Addendum Number One

Drawings and Specifications Dated August 17, 2007

Portland Harbor Hotel Annex

Archetype, P.A.

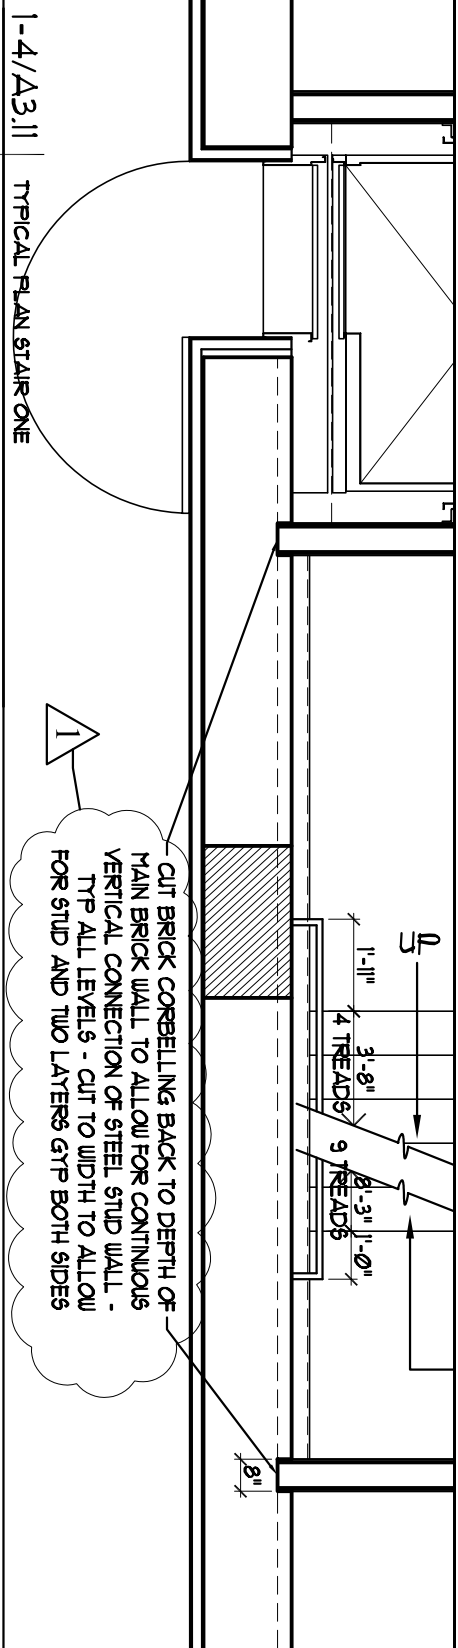
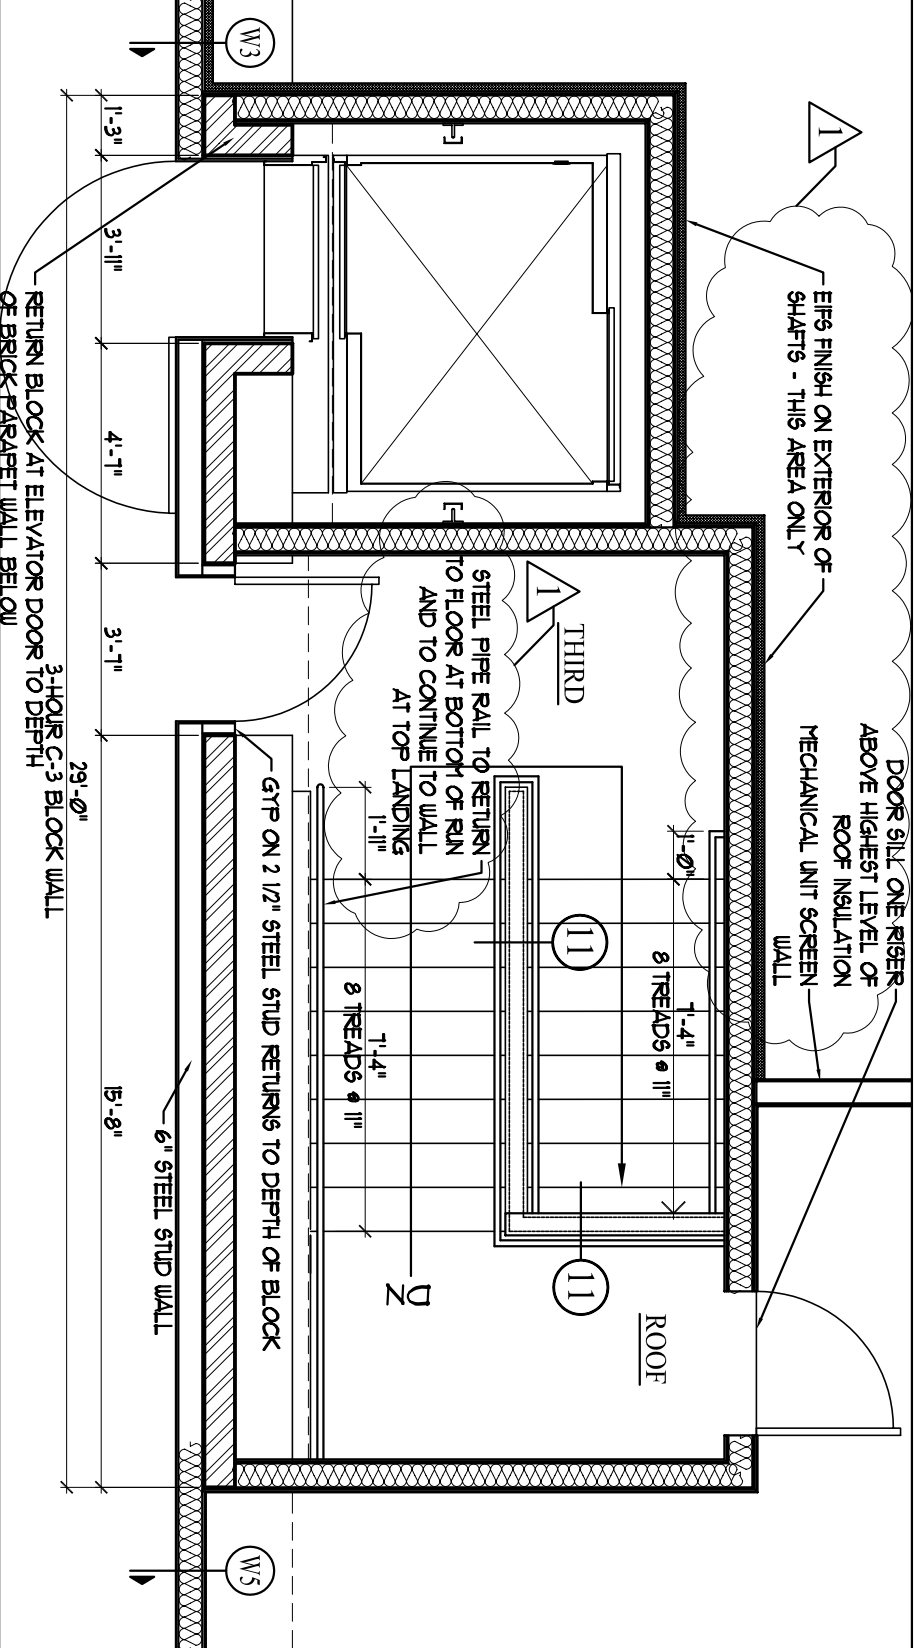
9. **Modification & Clarification:** Sheet A3.11 – Stair One Sections and Details; see attached drawings **AD1.6, AD1.7 and AD1.8 – Revised Details Stair One**. General Modification: Details 6-10/A3.11 – Delete reference to “galvanized” steel pipe rail. Rail shall be painted steel schedule 40, 1 ½” pipe. Clarification of dimensions for C-3 block wall at top of existing parapet, additional riser at roof landing to allow for one riser height above finished roof deck, and addition of steel connection detail for attachment of pipe rail to existing brick wall. Note the modification of finish material, also noted on AD1.3 – Rooftop Screen Plan, at exterior of stair and elevator shaft walls. Where shown, EIFS finish will be used on the walls, and lead-coated copper will be used on faces which are visible from the street. **Demolition sub-contractor note:** Detail 1/AD1.6 note references, “Cut brick corbelling back to depth of main brick wall to allow for continuous vertical connection of steel stud wall – typical all levels – cut to width to allow for stud and two layers of gyp both sides (8” total width, plus room for installation)”. This drawing shall be coordinated with, and included in its entirety with the demolition drawings.

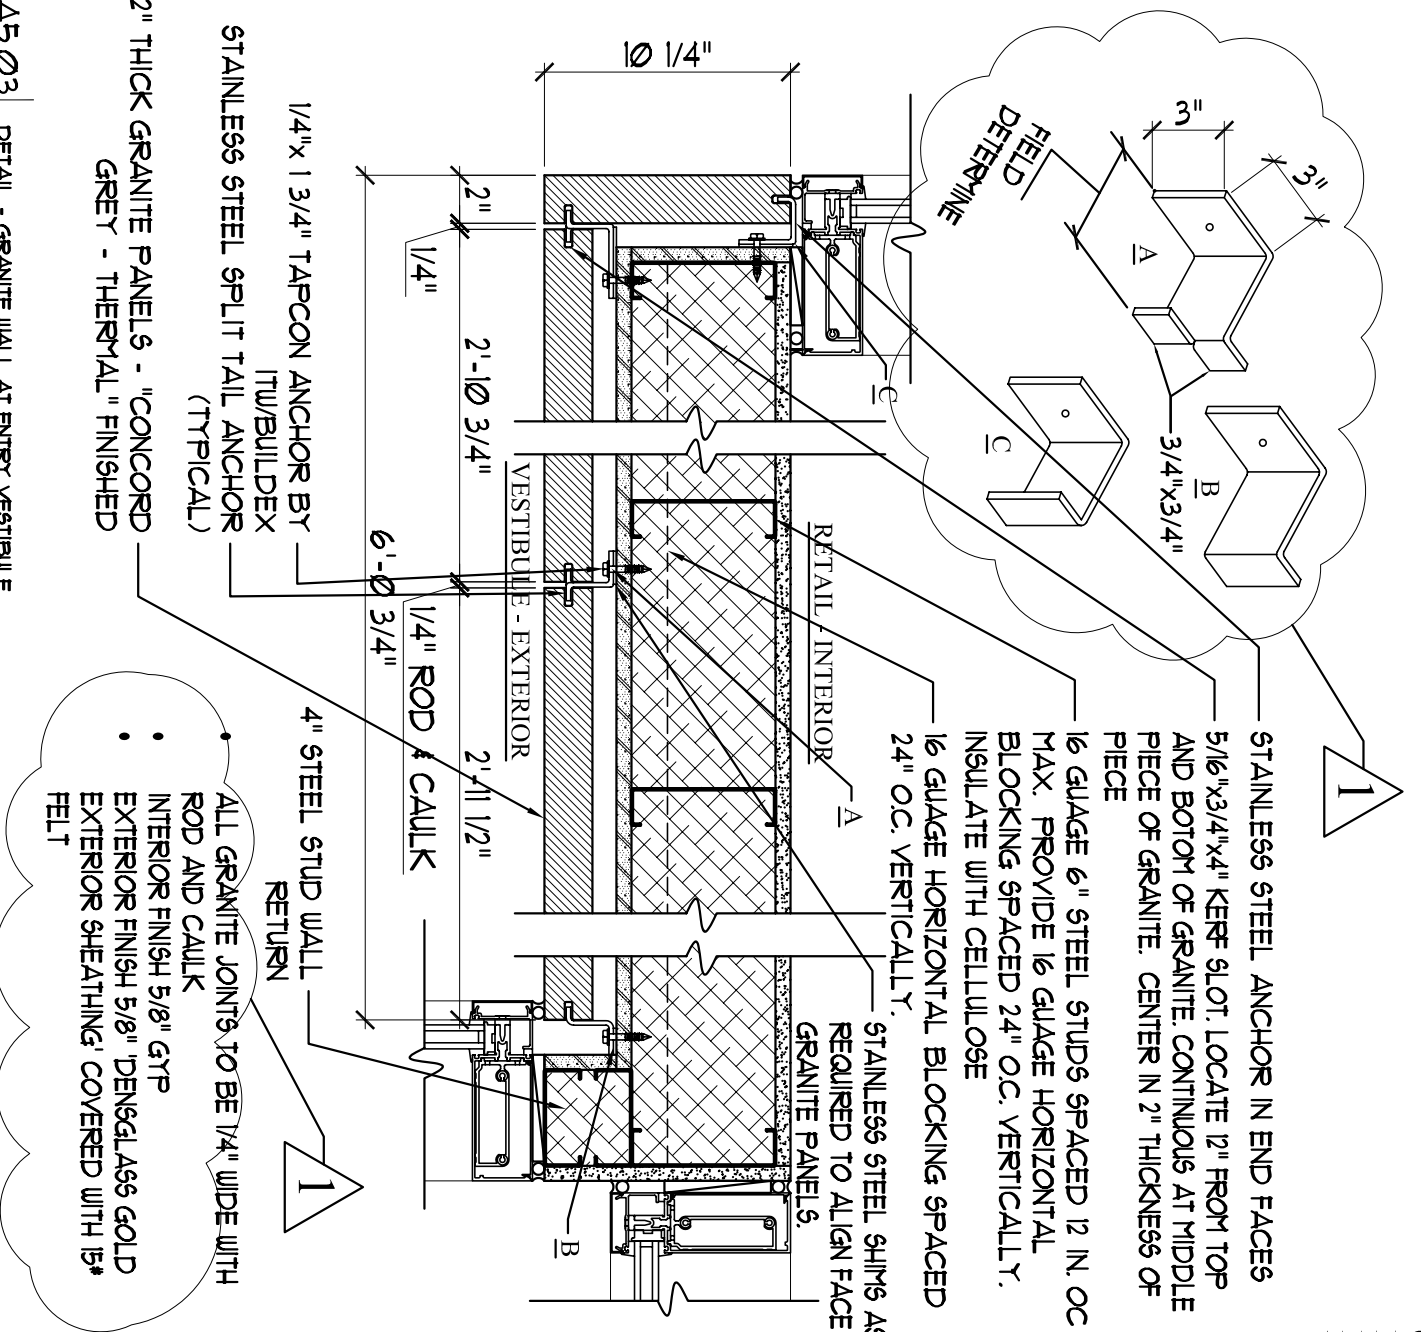
10. **Clarification:** Sheet A5.03 – Details; see attached drawing **AD1.9 – Plan Detail Granite Wall Entry Vestibule** for clarification of anchors for granite panels, shapes labeled ‘A’, ‘B’ and ‘C’.

CLARIFICATION OF PLAN
DETAIL AT GRANITE
PANEL WALL AT ENTRY
VESTIBULE

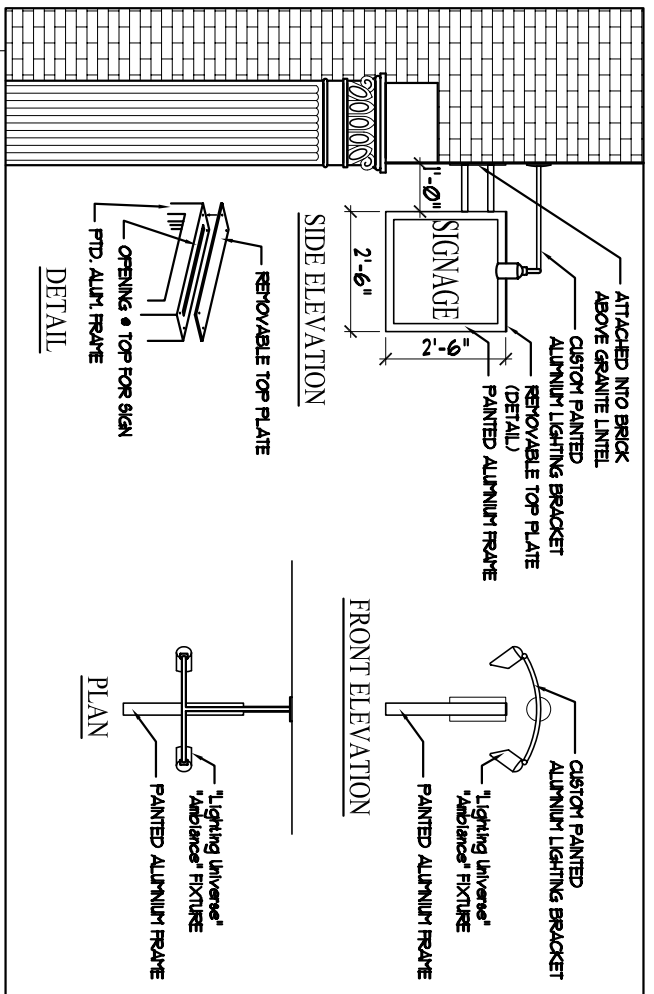
12. **Modification:** Sheet A5.01 – Storefront Details; see attached drawing **AD1.11 – Signage Details** for location and detailing of three signs to be located as shown. These signs shall be coordinated with E1.2 (also attached) for location and materials to be provided by electrical contract for power and installation of lights as shown.

AD 1.12	ADDENDUM TO SHEET S3	Date 31 August 2007	Scale 1/8" = 1'-0"	ARCHETYPE, P.A. ARCHITECTS 48 Union Wharf Portland, Maine 04101 (207) 772-6022 Fax (207) 772-4056
	Project: PORTLAND HARBOR HOTEL ANNEX	STRUCTURAL FRAMING PLAN		
	468-470 FORE STREET PORTLAND, MAINE

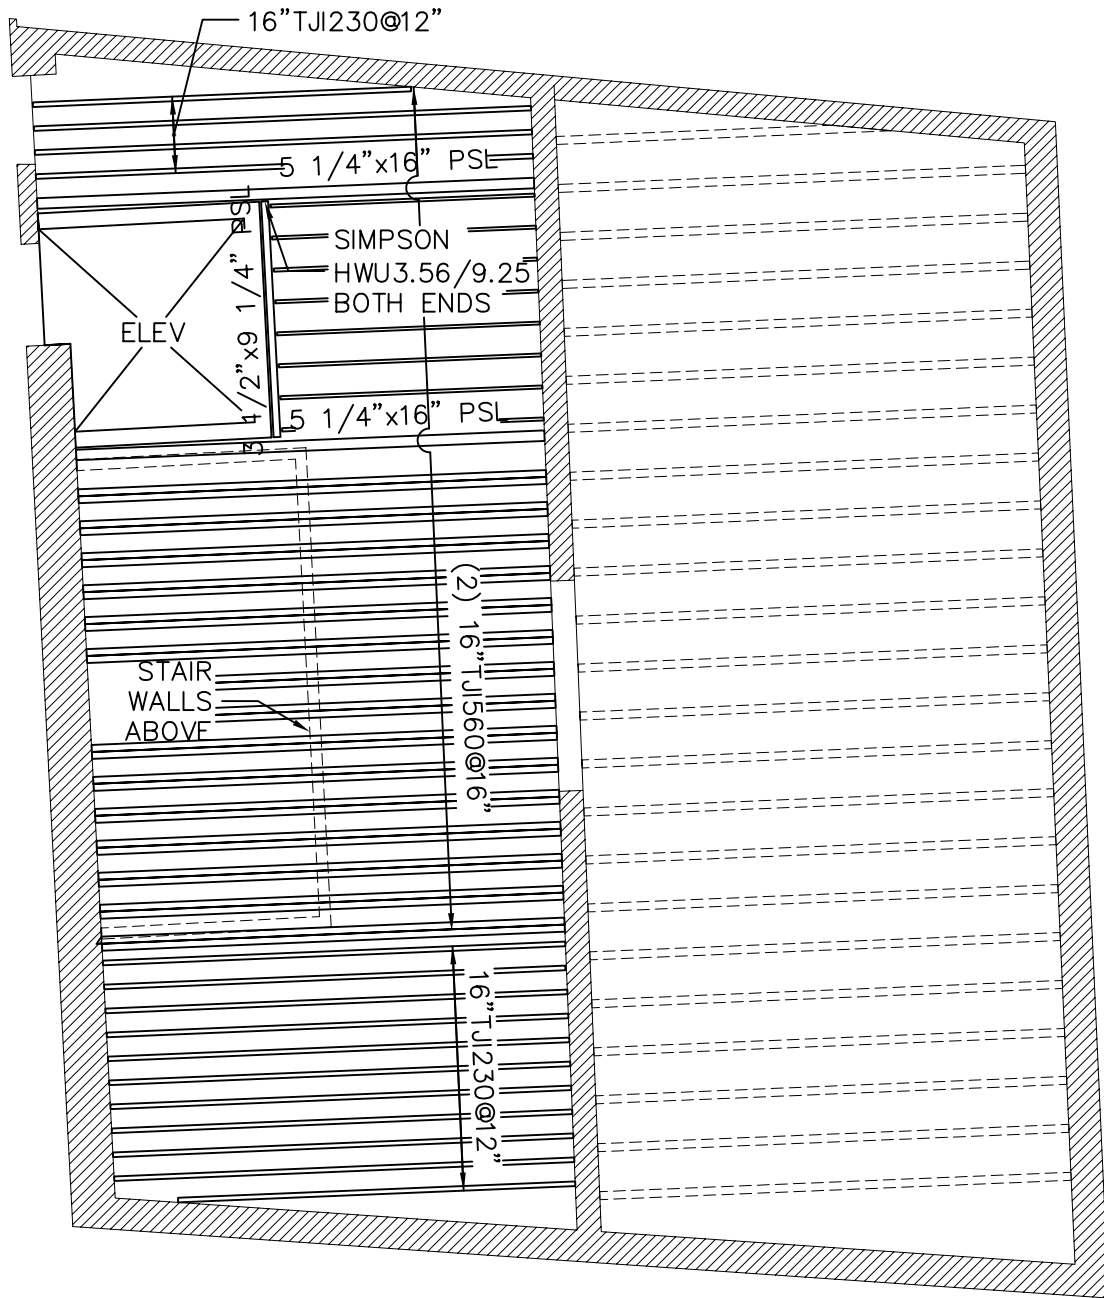
14. **Modification:** Sheets S3 through S7 – Structural Framing Plans; see attached drawings **AD1.12, AD1.13, AD1.14, AD1.15, AD1.16 – Structural Framing Plans** for

ADD FRAMING TO SHEET S3.
 EXIST FRAMING TO REMAIN SHOWN DASHED.
 LOWER EXISTING BRICK SHELF TO NEW
 BEARING ELEVATION.

AD 1.13	ADDENDUM TO SHEET S4	Date 31 August 2007	Scale 1/8" = 1'-0"	ARCHETYPE, P.A. ARCHITECTS 48 Union Wharf Portland, Maine 04101 (207) 772-6022 Fax (207) 772-4056
	Project: PORTLAND HARBOR HOTEL ANNEX	STRUCTURAL FRAMING PLAN		
	468-470 FORE STREET PORTLAND, MAINE

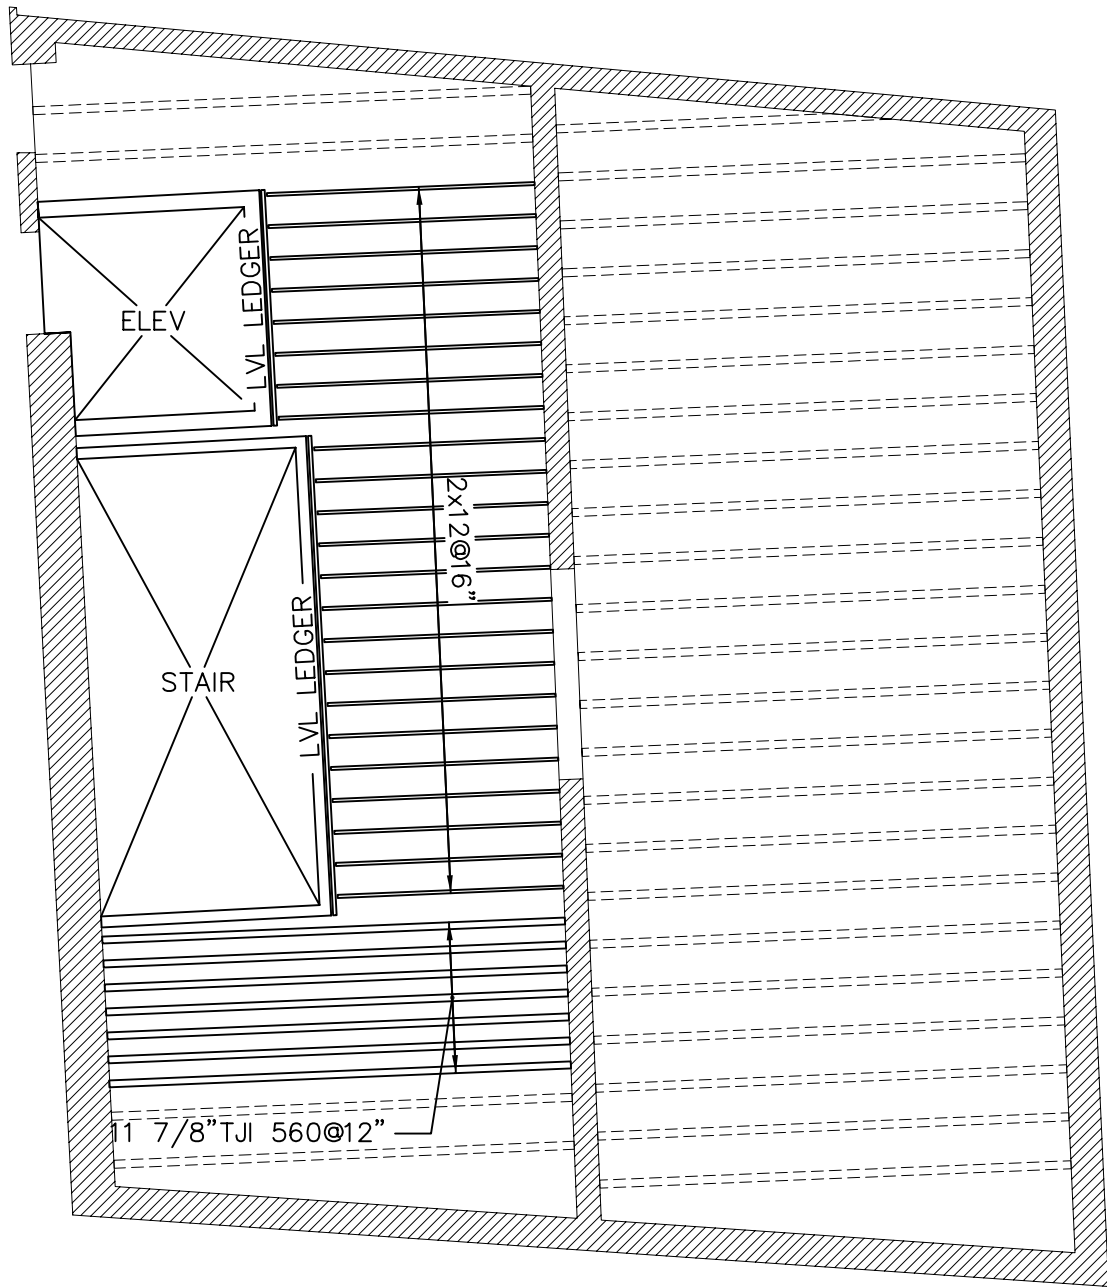
REPLACES FRAMING SHOWN ON S4.
 EXIST FRAMING TO REMAIN SHOWN DASHED.
 ELEV & STAIRWALLS ARE 6", A8 GAGE STEEL STUDS@12".

AD 1.14	ADDENDUM TO SHEET S5	Date 31 August 2007	Scale 1/8" = 1'-0"	ARCHETYPE, P.A. ARCHITECTS <small>48 Union Wharf Portland, Maine 04101 (207) 772-6022 Fax (207) 772-4056</small>
	Project: PORTLAND HARBOR HOTEL ANNEX	STRUCTURAL FRAMING PLAN		
	<small>468-470 FORE STREET PORTLAND, MAINE</small>

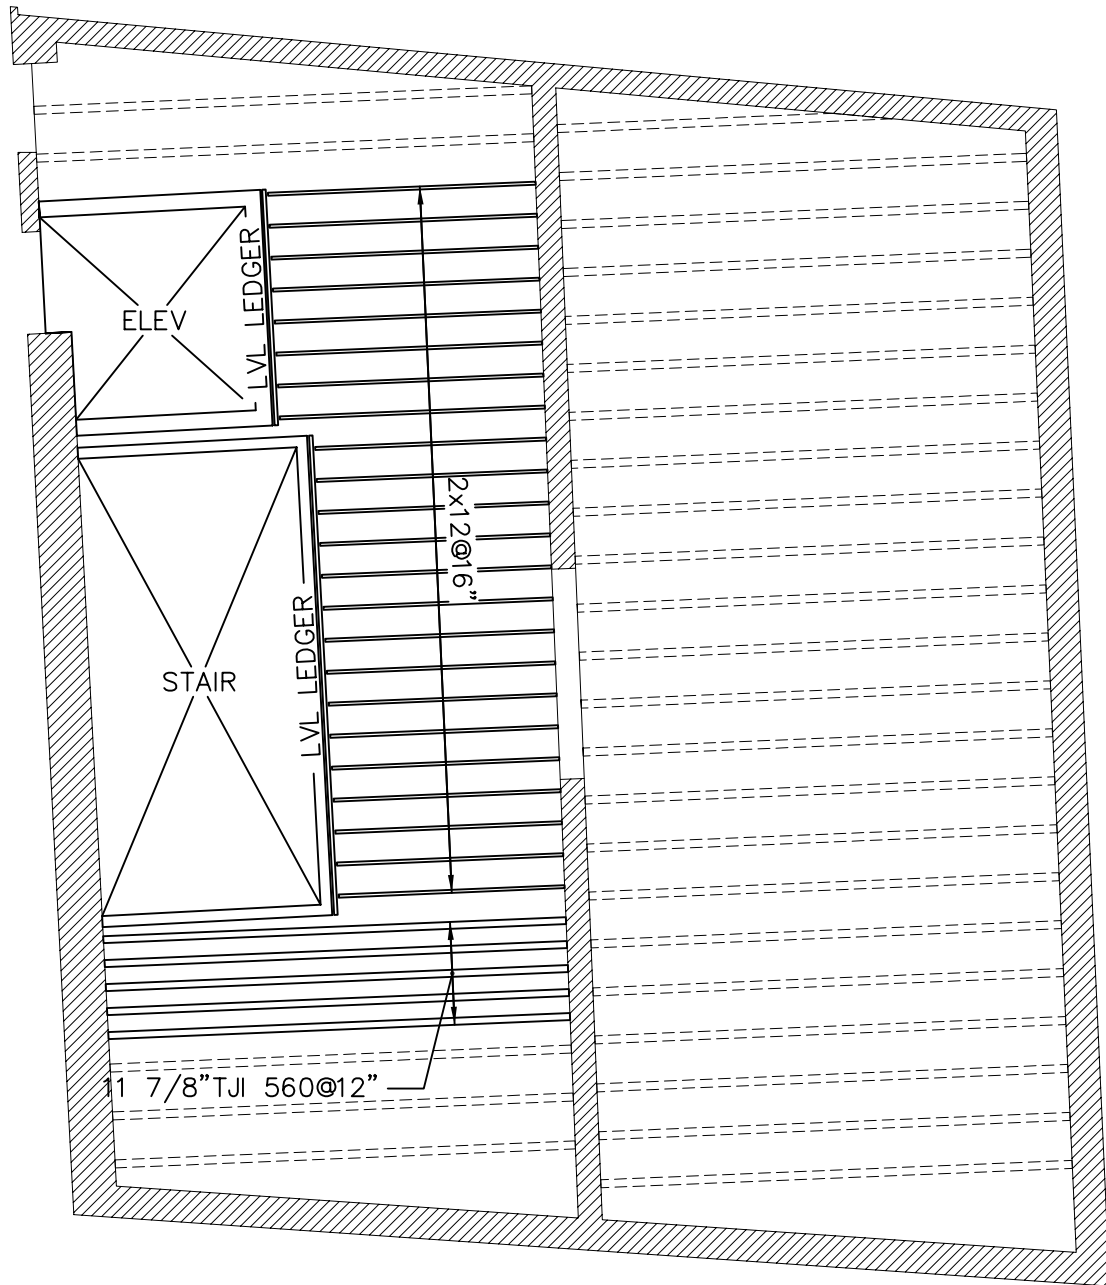
21. **Modification:** SHEET S5 - First Floor Framing Plan; change size of beam spanning from 2-A to 2-C from W12x26 to W14x30. Add HSS4x4x0.1875 at 2-B bearing on W14x30.

REPLACES FRAMING SHOWN ON S5.
 EXIST FRAMING TO REMAIN SHOWN DASHED.
 ELEV & STAIRWALLS ARE 6", 18 GAGE STEEL STUDS@12".

AD 1.15	ADDENDUM TO SHEET S6	Date 31 August 2007	Scale 1/8" = 1'-0"	ARCHETYPE, P.A. ARCHITECTS 48 Union Wharf Portland, Maine 04101 (207) 772-6022 Fax (207) 772-4056
	Project: PORTLAND HARBOR HOTEL ANNEX	STRUCTURAL FRAMING PLAN		
	468-470 FORE STREET PORTLAND, MAINE

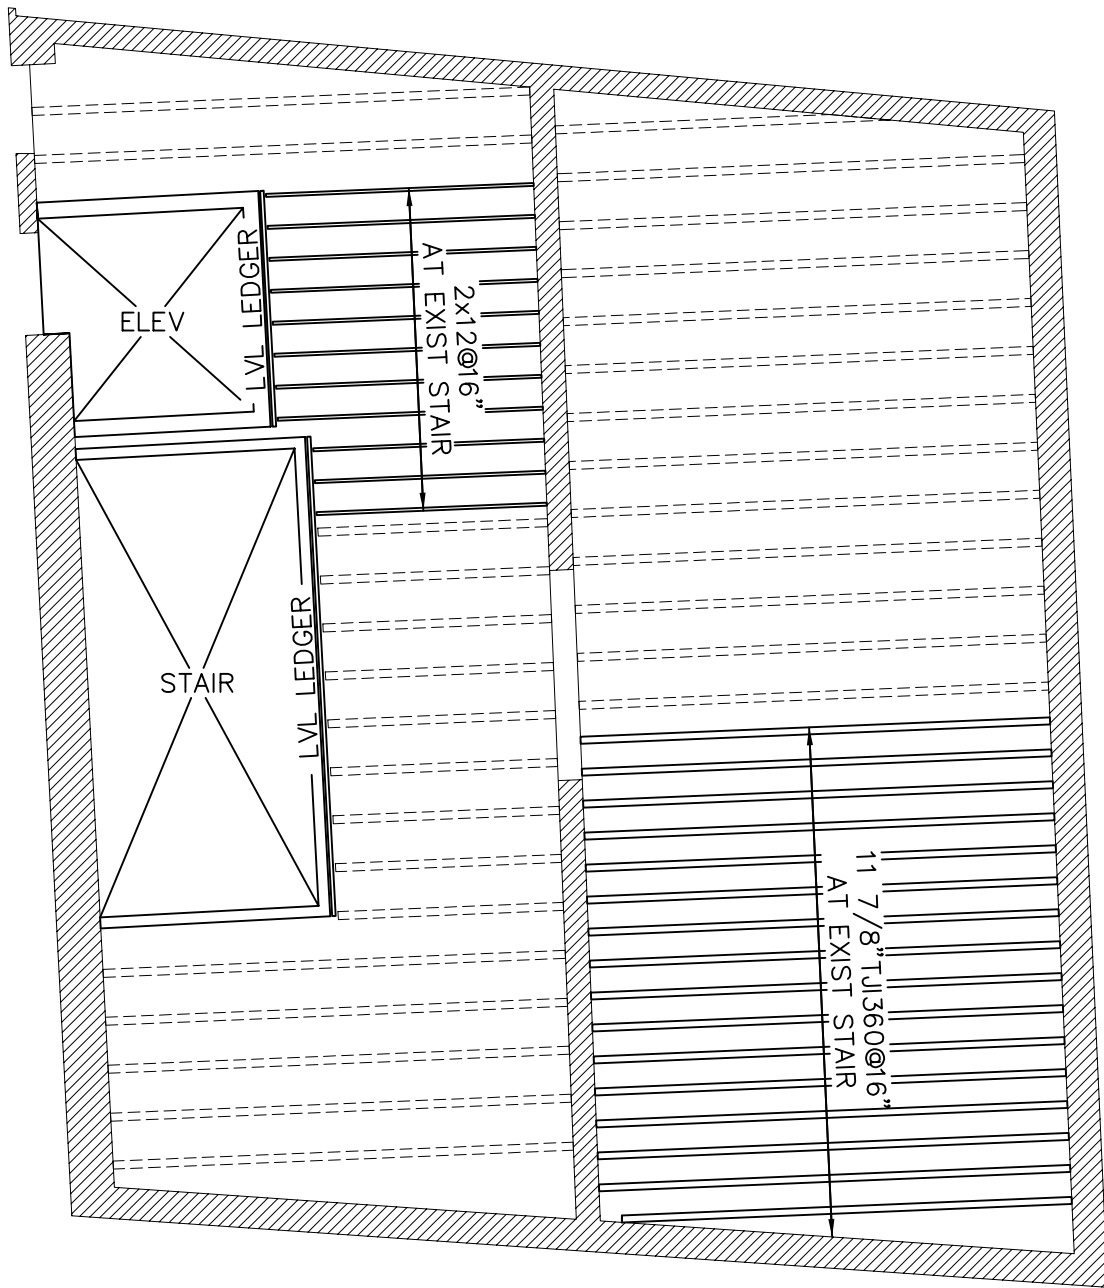
22. **Modificaiton:** SHEET S6 - 2ND and 3rd Floor Framing Plan; omit W12x26 spanning from 2-A to 2-C. Add HSS4x4x0.1875 at 2-B. Add W8x10 from 2-A to 2-B.

Q1. On drawing S6 there is a beam on the 2-line that is just hanging out into the building, is there additional framing around this?

REPLACES FRAMING SHOWN ON S6.
 EXIST FRAMING TO REMAIN SHOWN DASHED.
 ELEV & STAIRWALLS ARE 6", 18 GA STEEL STUDS@12".

A. See clarification and modification items 21 through 24 listed above in this addendum.
